Panasonic Position on ENERGY STAR TVs Draft 2 Specification

EPA Stakeholder Meeting

18 October 2007

Draft 2 Spec Favors Smaller Size Models

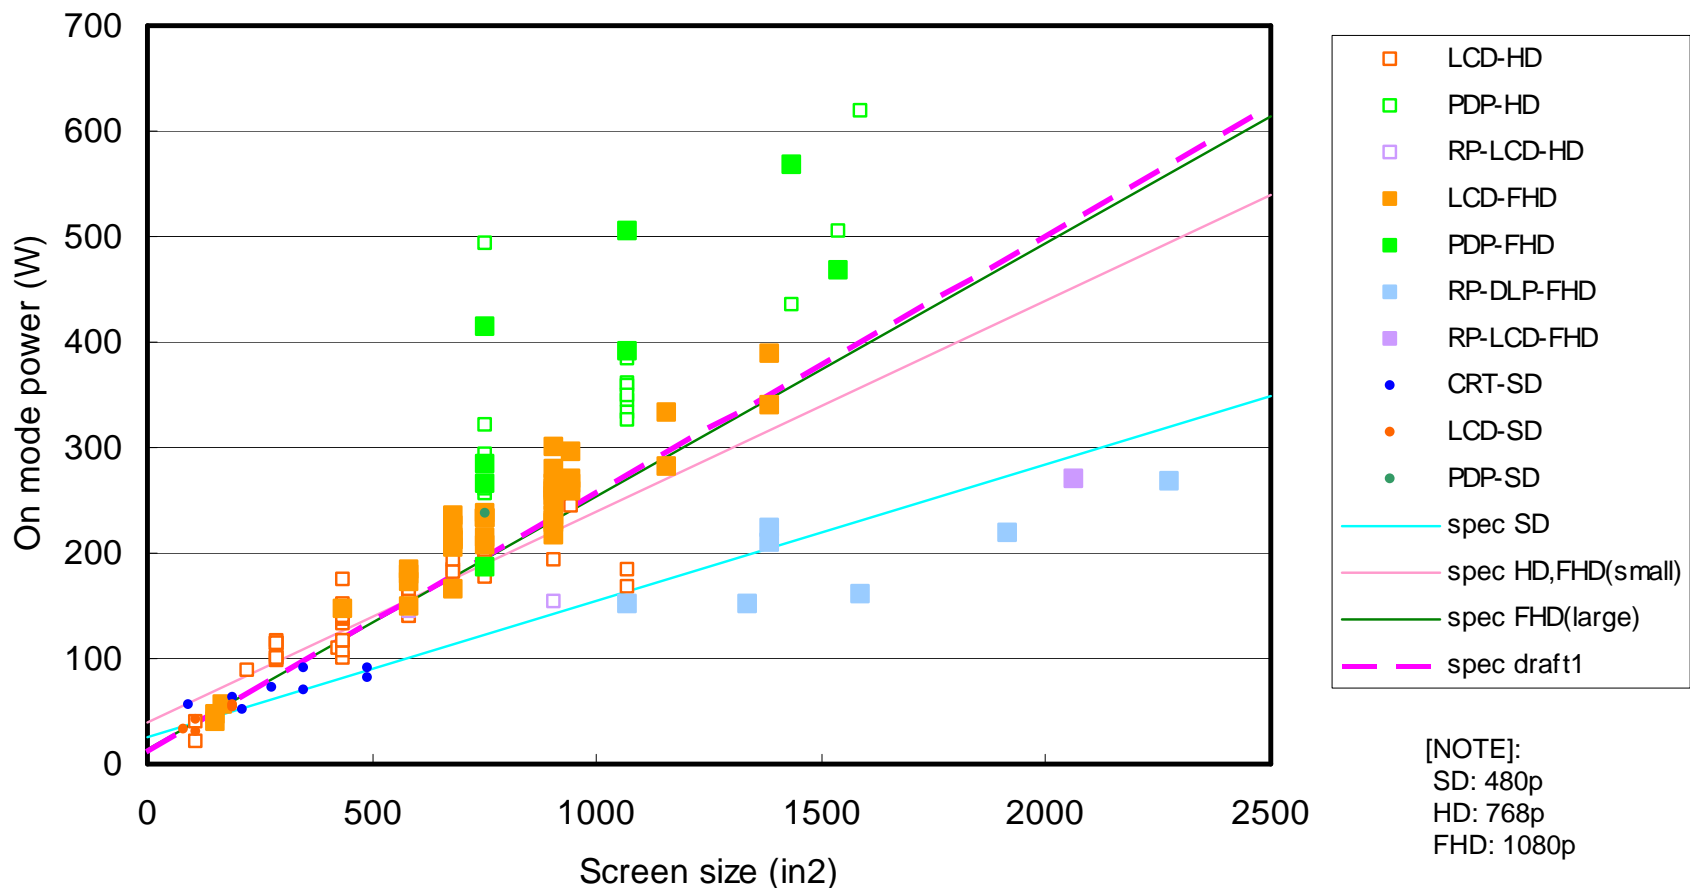
- Draft 2 spec for FHD nearly same as earlier version
- Draft 2 spec for HD more stringent for large (>40") size

RP Pulls Down ENERGY STAR Slope

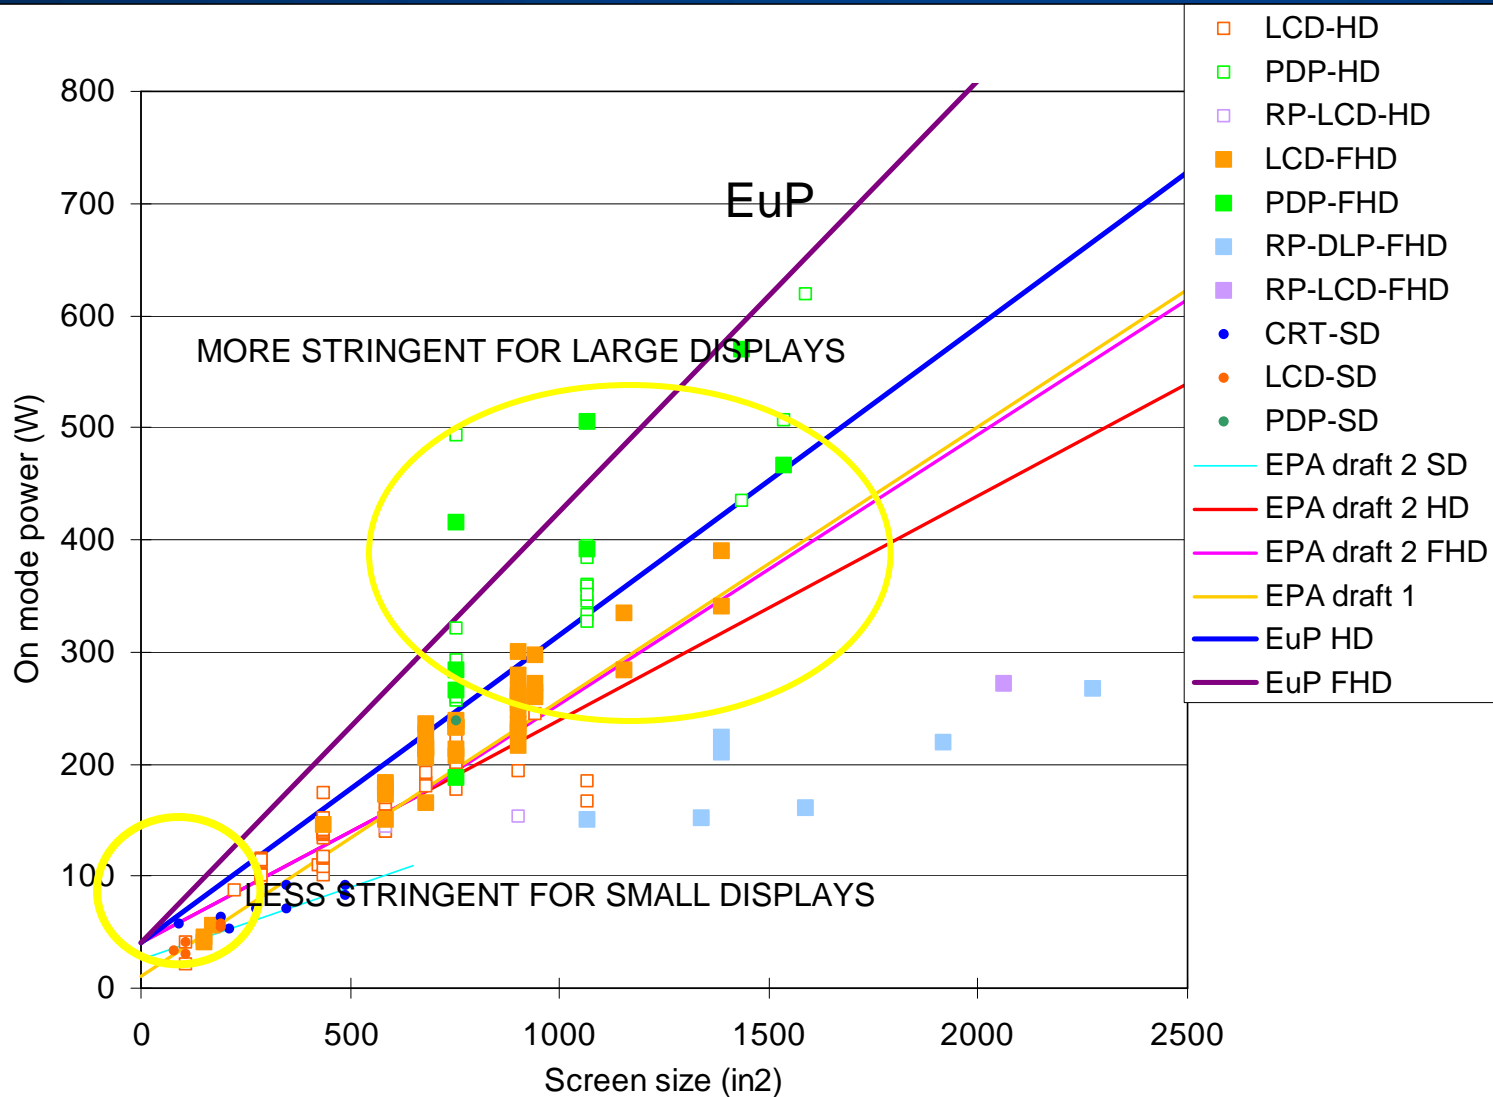
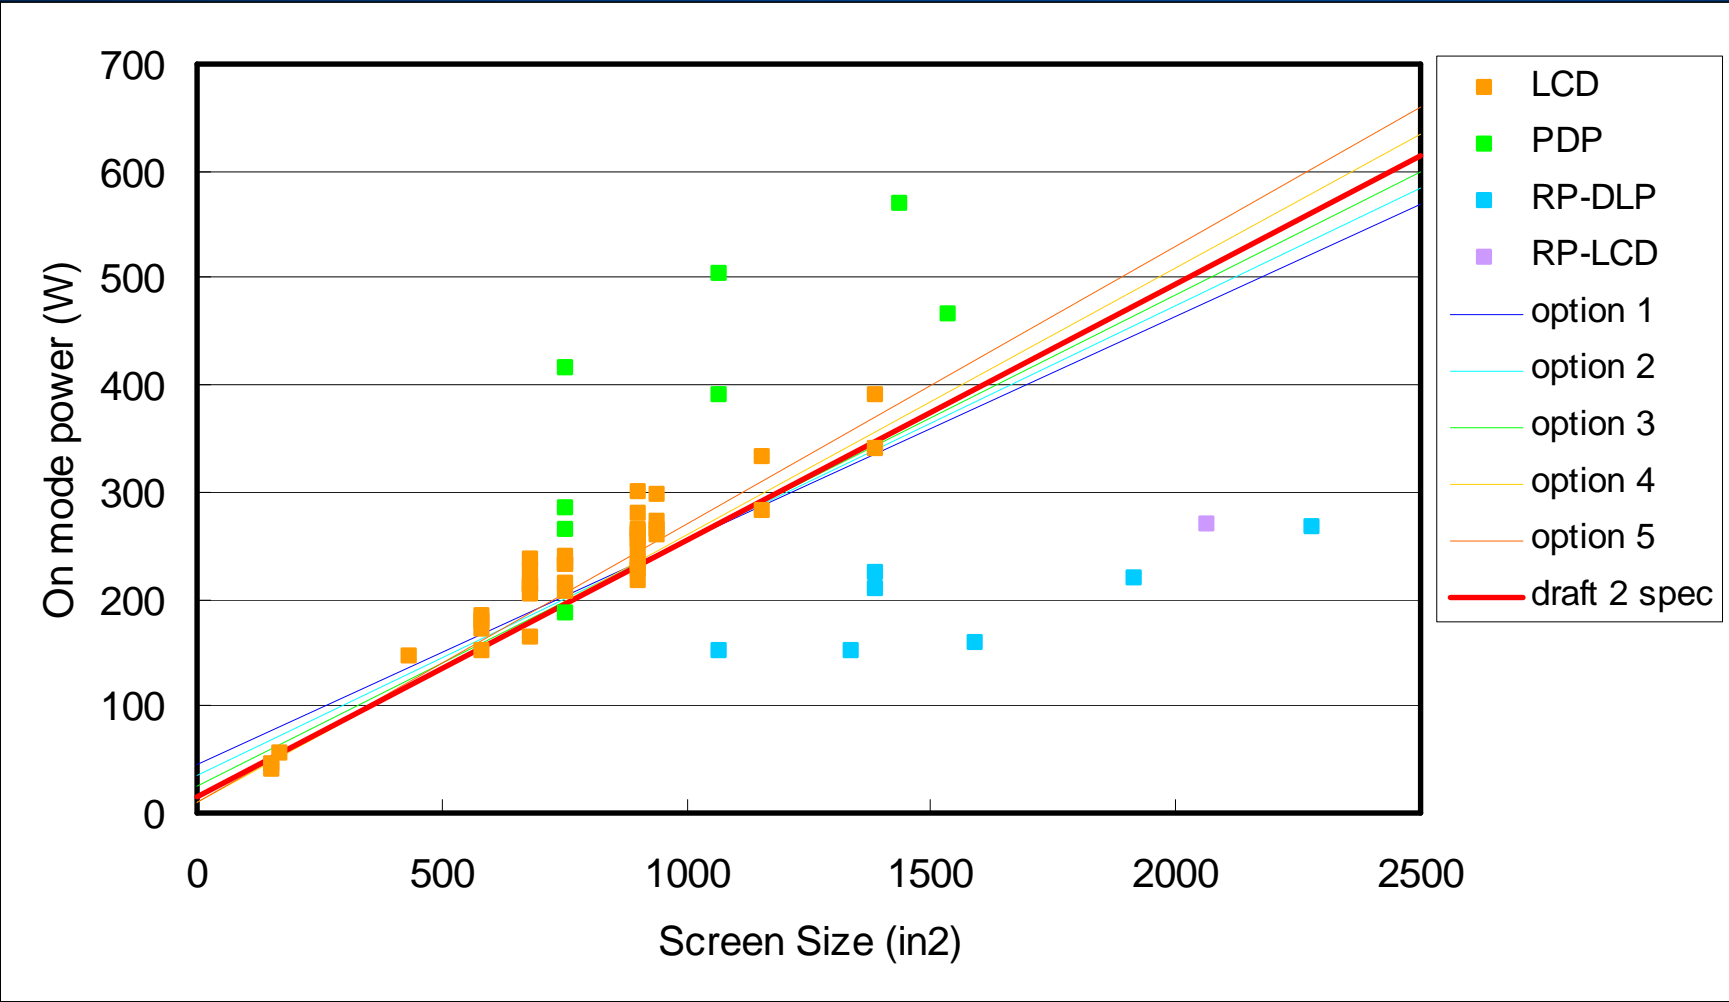
Over-Representation of RP in Large Screen FHD
